STATE OF CONNECTICUT  
CONNECTICUT SITING COUNCIL

IN RE: :  
 :  
 :  
 APPLICATION OF SPRINT NEXTEL : DOCKET NO. 334  
 CORPORATION FOR A CERTIFICATE OF :  
 ENVIRONMENTAL COMPATIBILITY AND :  
 PUBLIC NEED FOR THE CONSTRUCTION, :  
 MAINTENANCE AND OPERATION OF A :  
 TELECOMMUNICATIONS FACILITY AT 186 :  
 BLACK ROCK TURNPIKE, REDDING, :  
 CONNECTICUT : JULY 24, 2007

RESPONSES OF CELLCO PARTNERSHIP D/B/A VERIZON WIRELESS  
TO CONNECTICUT SITING COUNCIL PRE-HEARING INTERROGATORIES

**Existing Verizon Wireless Cellular Coverage  
 Redding Connecticut and Surrounding Area**

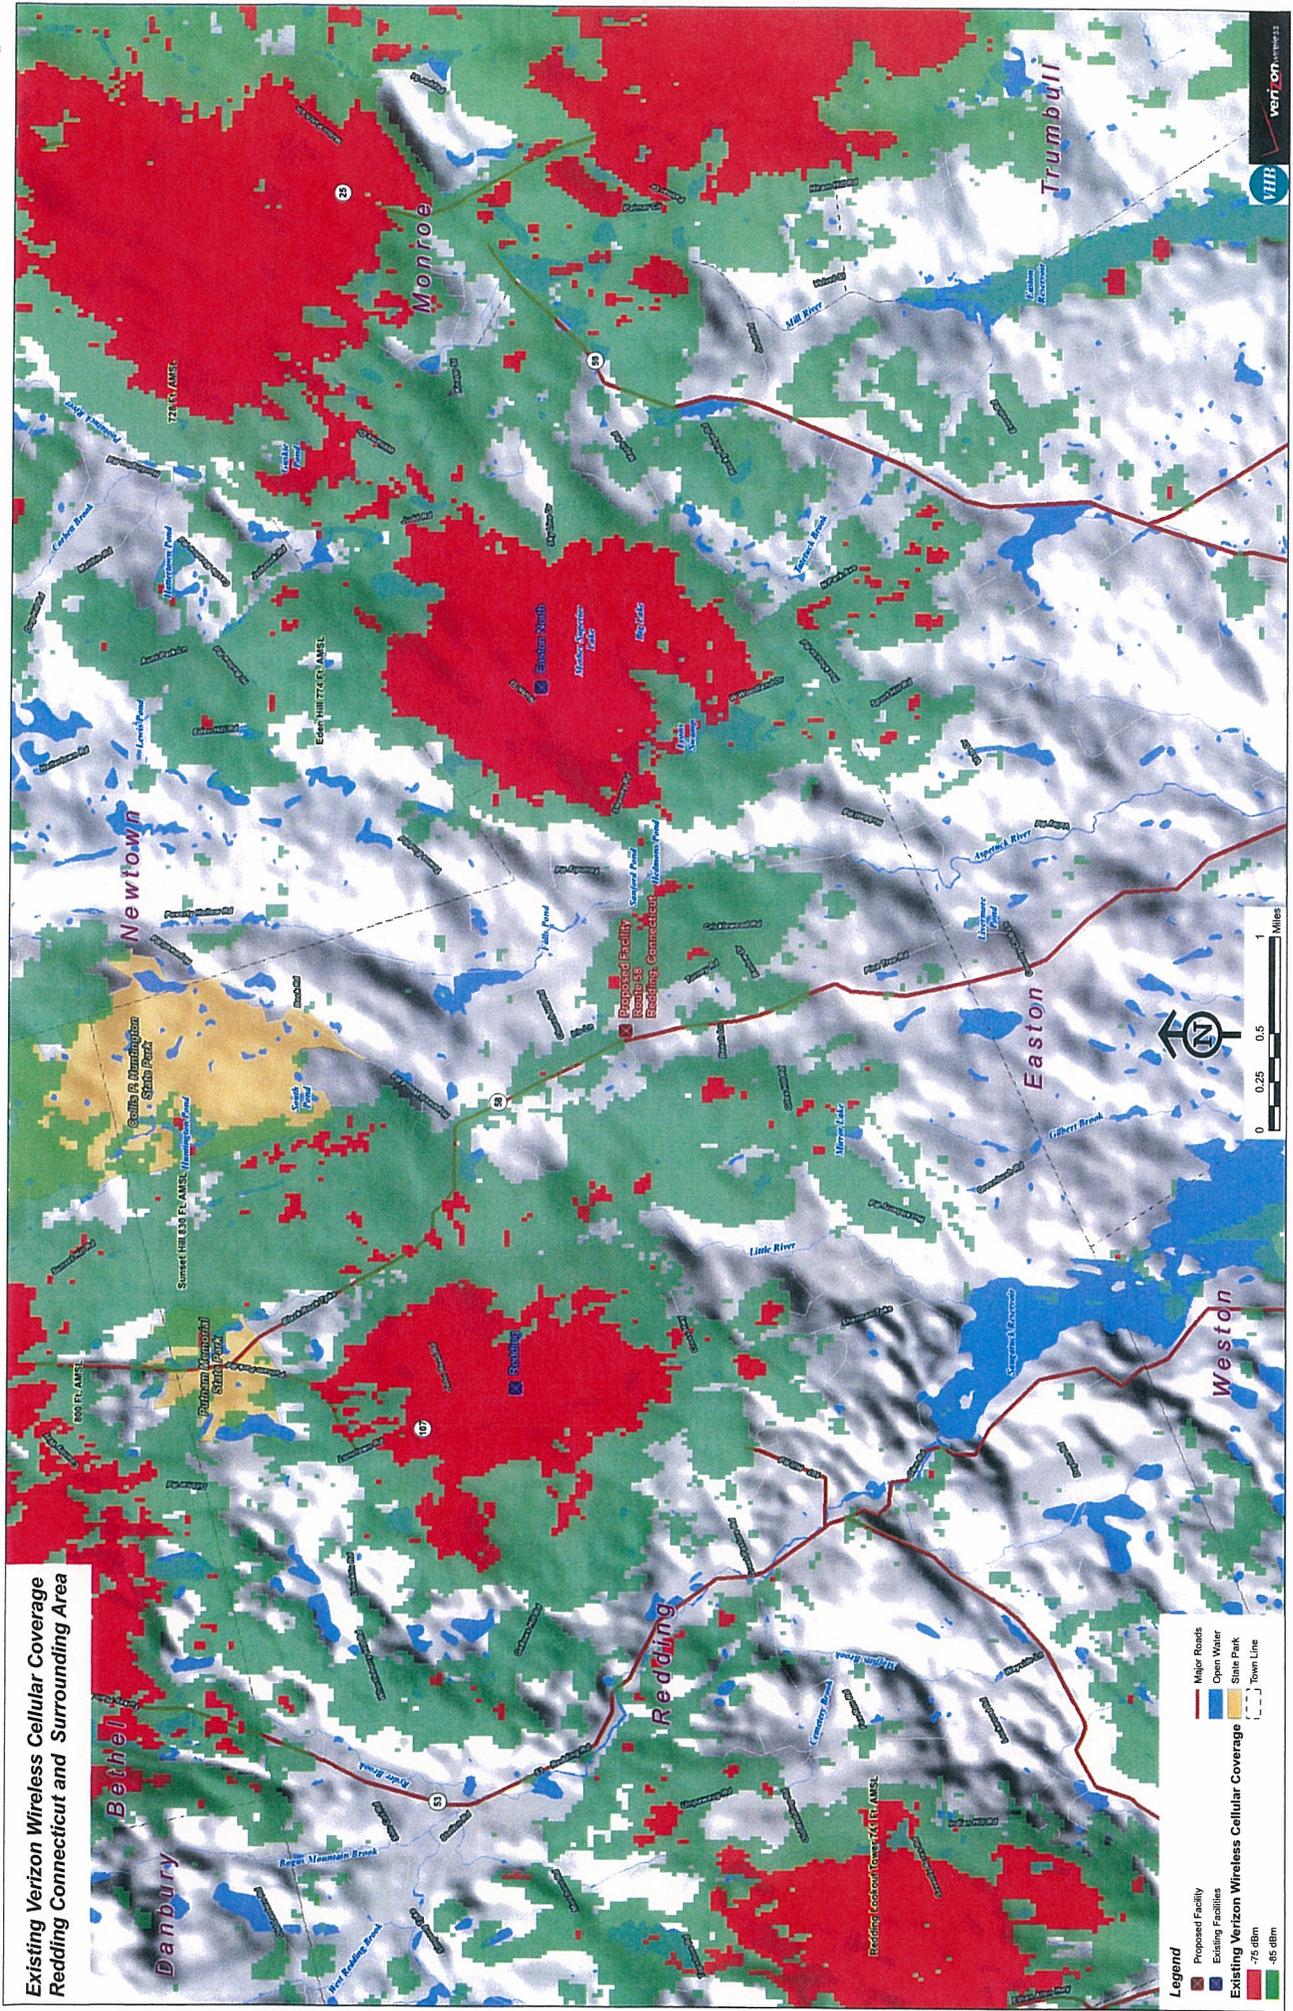
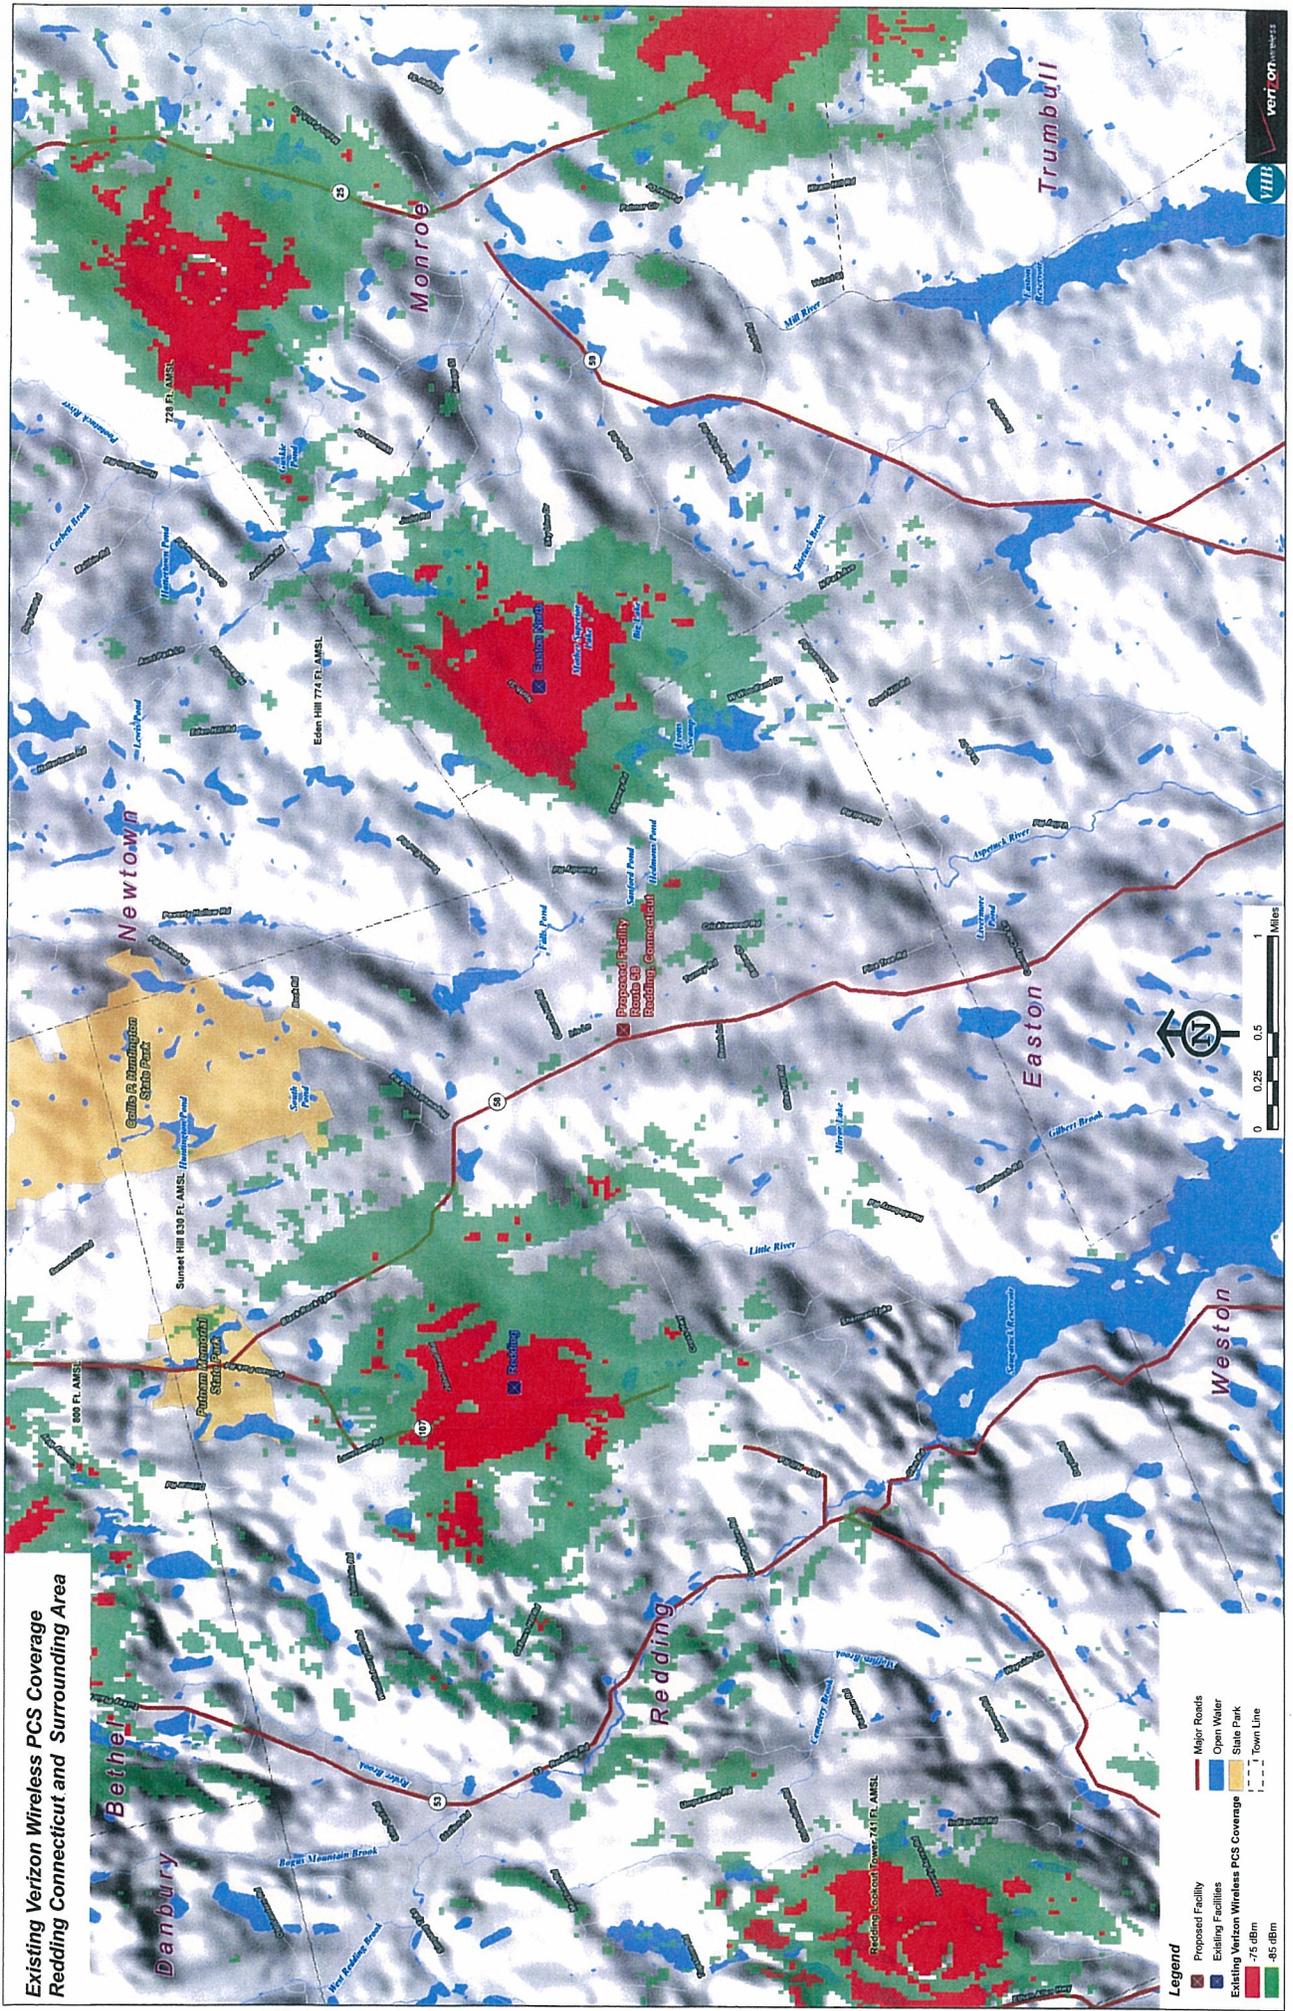
Provide propagation maps showing Cellco's existing coverage and Cellco's proposed coverage.

Coverage plots showing existing coverage at the cellular and PCS frequencies are included at Attachment 1. Coverage plots showing proposed coverage at cellular and PCS frequencies at the 110-foot level are included in Attachment 2.
